ILLINOIS POWER COMPANY

Subject: Illinois Power (IP) Company Request for  
Concurrence to Remove Additional  
Commodities from the Overinspection Program

ENCLOSURE 1  
TECHNICAL JUSTIFICATION FOR IP'S REQUEST  
FOR NRC CONCURRENCE TO TERMINATE  
THE OVERINSPECTION PROGRAM FOR  
ADDITIONAL COMMODITIES

ILLINOIS POWER RESPONSE TO NRC QUESTIONS  
IN ENCLOSURE 3 TO NRC'S APRIL 11, 1985, LETTER  
CONCERNING REQUESTS TO TERMINATE THE OVER INSPECTION PROGRAM  
FOR COMMODITIES OTHER THAN PIPING AND MECHANICAL SUPPORTS

FIGURE 1

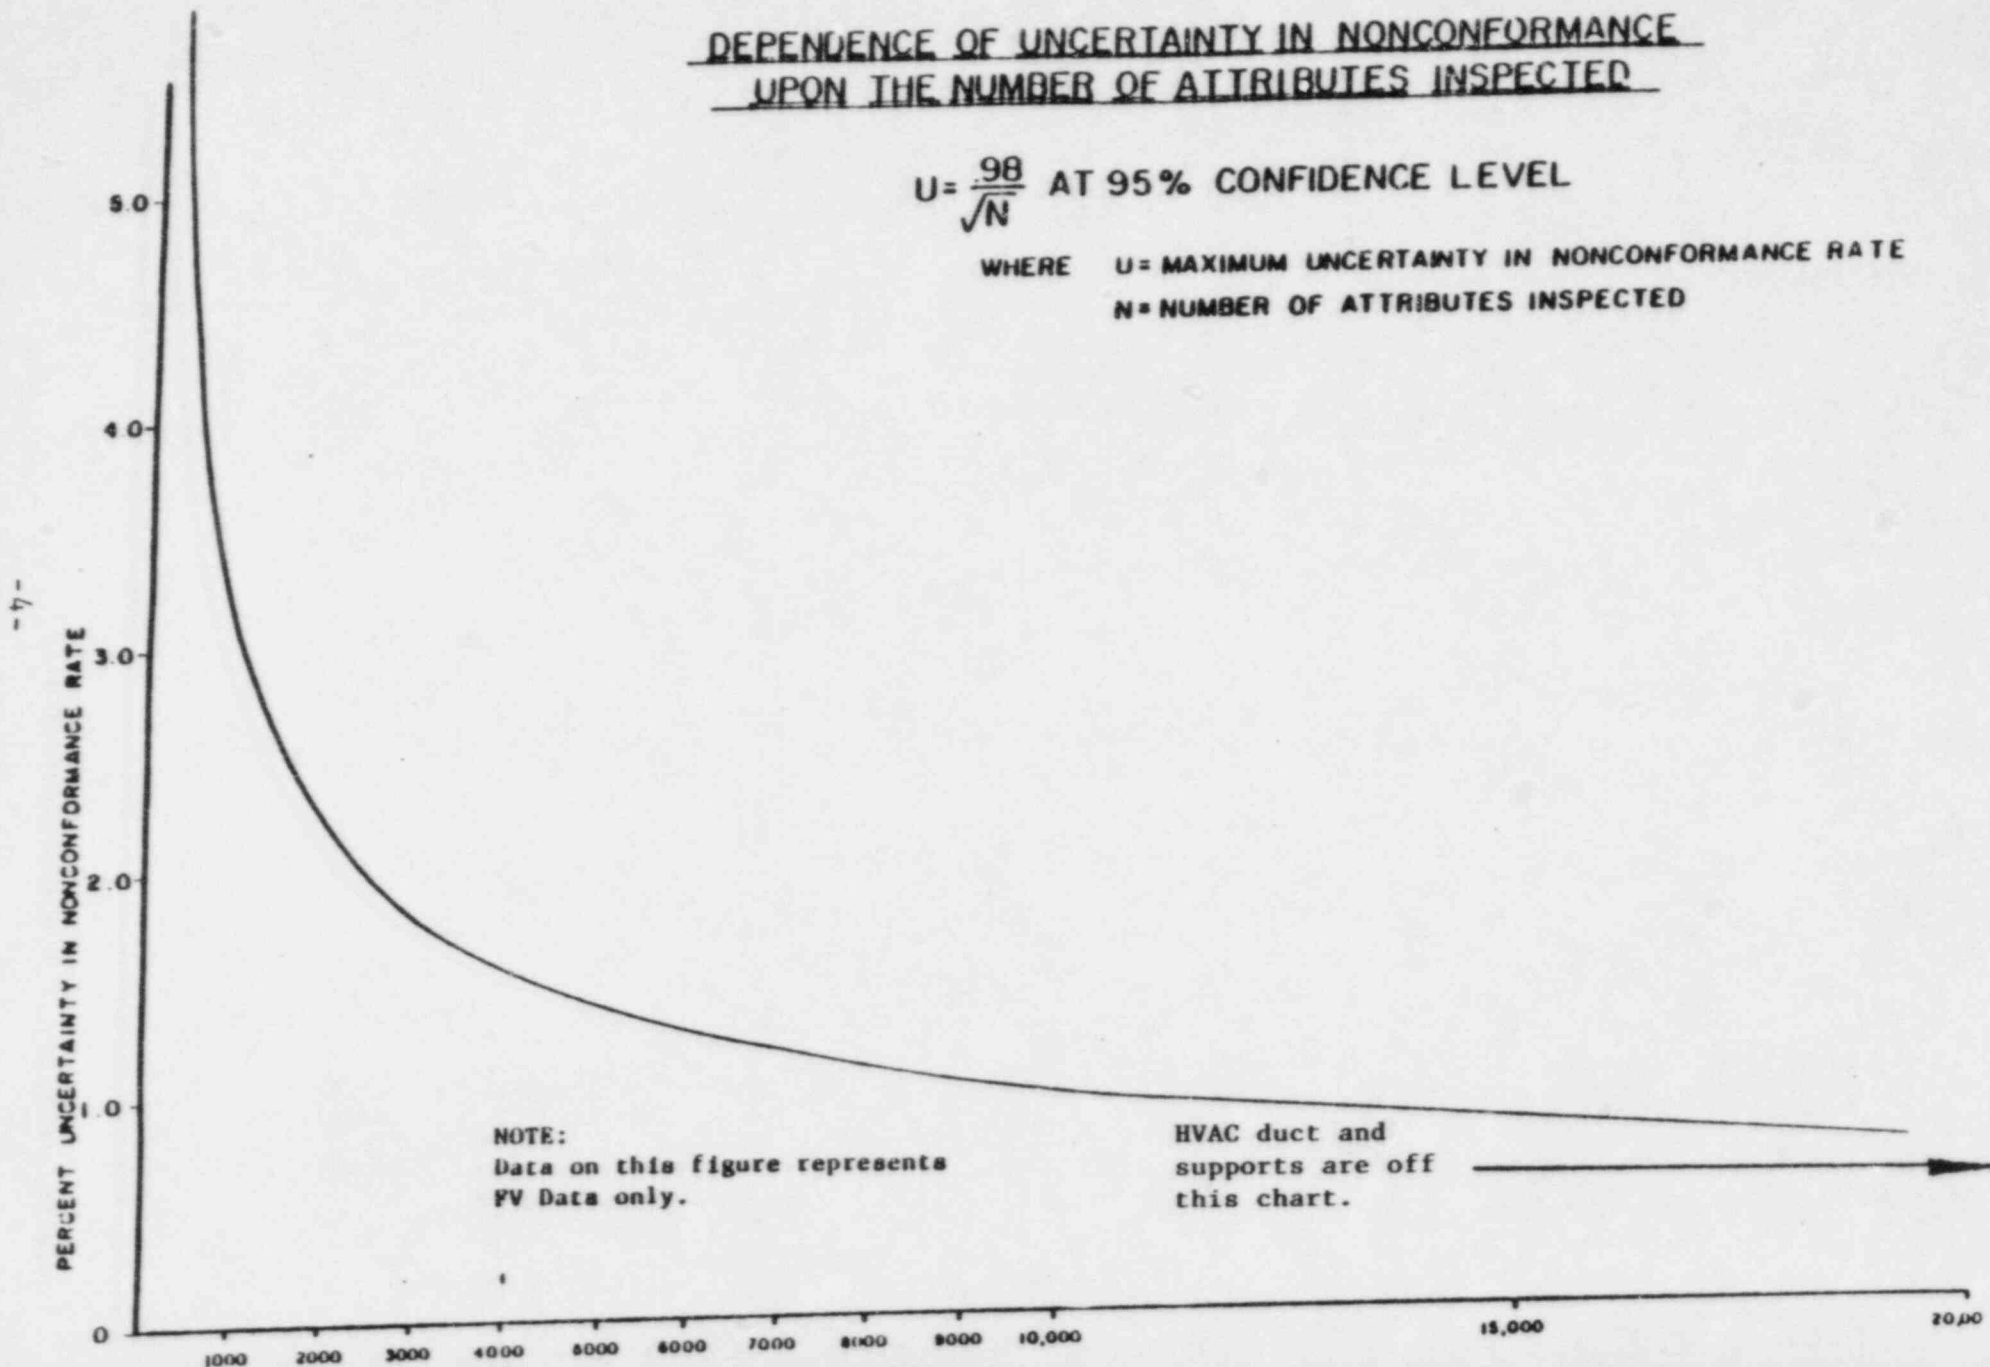
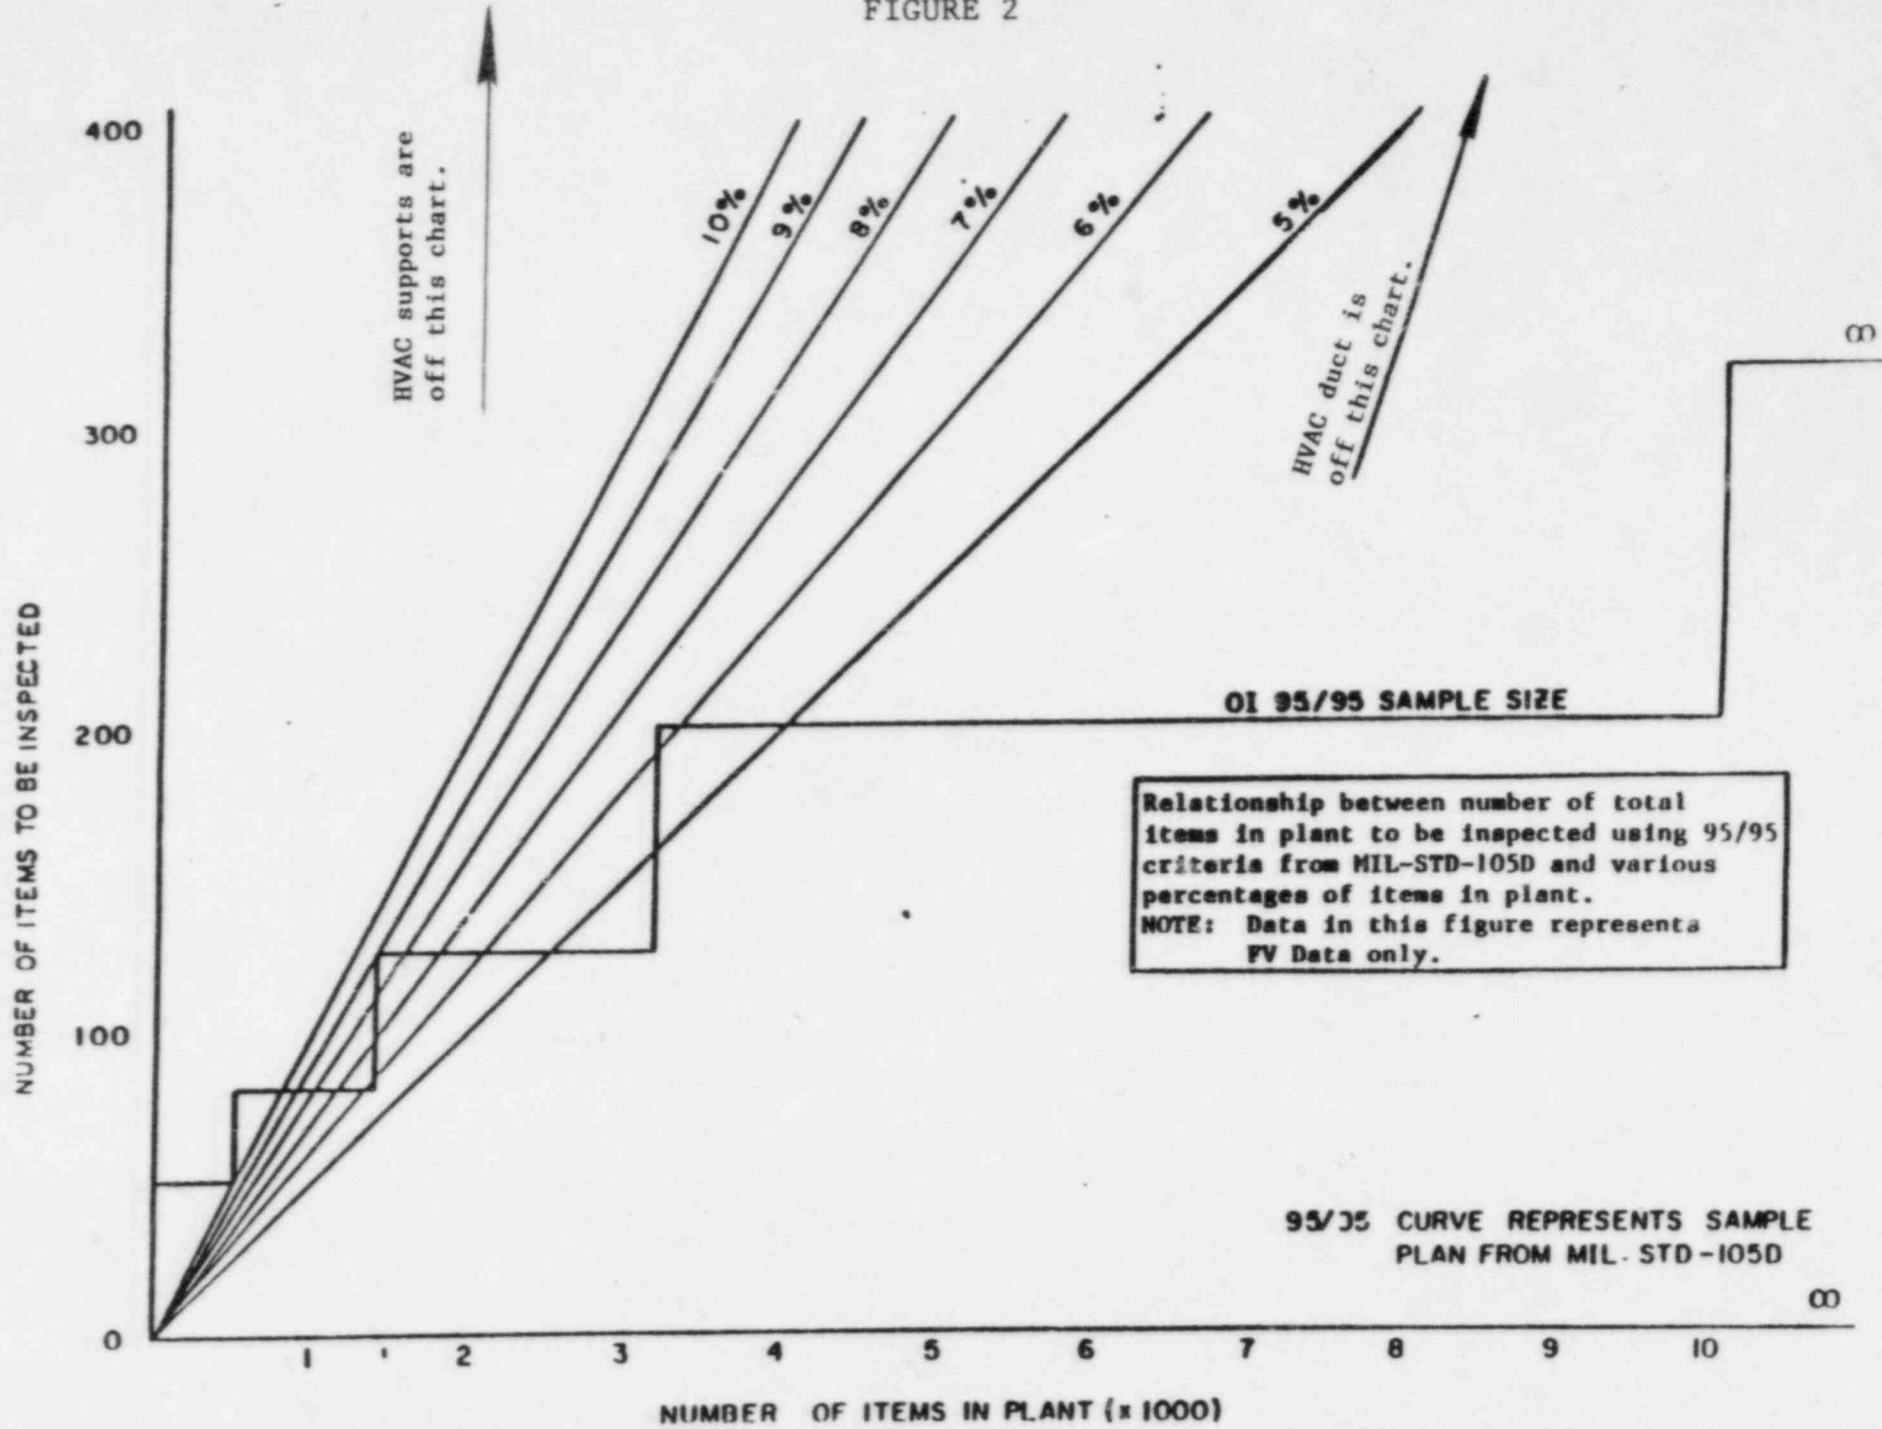
Based on the number of attributes inspected for each commodity, Figure 1 shows that the uncertainty associated with the reinspections are low, and further inspections are not expected to significantly reduce this uncertainty. In addition, Figure 2 shows that the 95/95 criterion, which is the basis for Overinspection Program sample inspection, is also satisfied for HVAC duct and duct supports.

Based on the number of items reinspected, the associated low uncertainties and the fact that the 95/95 criterion has been satisfied, IP Criterion 1 for termination of reinspection has been met.
